Building Consistency Meeting

Residential

Date: 7/1/09 Recorder and minutes prepared by: Danny Wooten/Jeff Griffin

North Carolina State Building Code, 2009 North Carolina Residential Code

Prescriptive lateral support for top of foundation walls

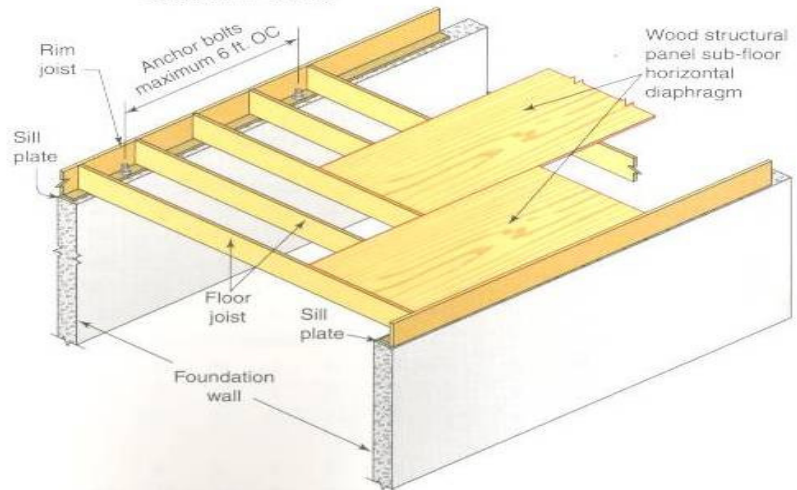
CHANGE SUMMARY: The prescriptive lateral restraint provisions for the top of concrete and masonry foundation walls based on soil type, height of wall, and unbalanced backfill height have been removed from the code.

Delete second paragraph without substitution:

Foundation walls that meet all of the following shall be considered laterally supported:

1. Full basement floor shall be 3.5 inches (89 mm) thick concrete slab poured tight against the bottom of the foundation wall;
2. Floor joists and blocking shall be connected to the sill plate at the top of wall by the prescriptive method called out in Table R404.1(1), or; shall be connected with an approved connector with listed capacity meeting Table R404.1(1);
3. Bolt spacing for the sill plate shall be no greater than per Table R404.1(2);

4. Floor shall be blocked perpendicular to the floor joists. Blocking shall be full depth within two joist spaces of the foundation wall, and be flat-blocked with minimum 2-inch-by-4-inch (51 mm by 102 mm) blocking elsewhere.
5. Where foundation walls support unbalanced load on opposite sides of the building, such as a daylight basement, the building aspect ratio, L/W , shall not exceed the value specified in Table R404.1(3). For such foundation walls, the rim board shall be attached to the sill with a 20 gage metal angle clip at 24 inches (610 mm) on center, with five 8d nails per leg, or an approved connector supplying 230 pounds per linear foot (3.36 kN/m) capacity.

CHANGE SIGNIFICANCE: Prior to the 2006 edition, the IRC and the legacy *CABO One- and Two-Family Dwelling Code* relied on the prescriptive provisions for anchor bolt spacing and floor framing connections to provide lateral restraint at the top of basement foundation walls. As the result of engineering analysis, the 2006 IRC introduced additional requirements for anchor bolt spacing, floor joist attachment and blocking, and maximum aspect ratio for walk-out basements. The tabular values for these new requirements varied based on the height of the foundation wall, the maximum unbalanced backfill height, and the type of soil. Deletion of these lateral restraint provisions brings the 2009 IRC into agreement with the 2000 and 2003 editions.

Proponents of removing the top of foundation wall lateral restraint provisions reasoned that the traditional prescriptive provisions for anchor bolts and floor system connections have performed well for many years without substantiated problems or failures. It was also argued that the engineering analysis used to justify introduction of the lateral restraint provisions was overly conservative and failed to take into account all design factors.
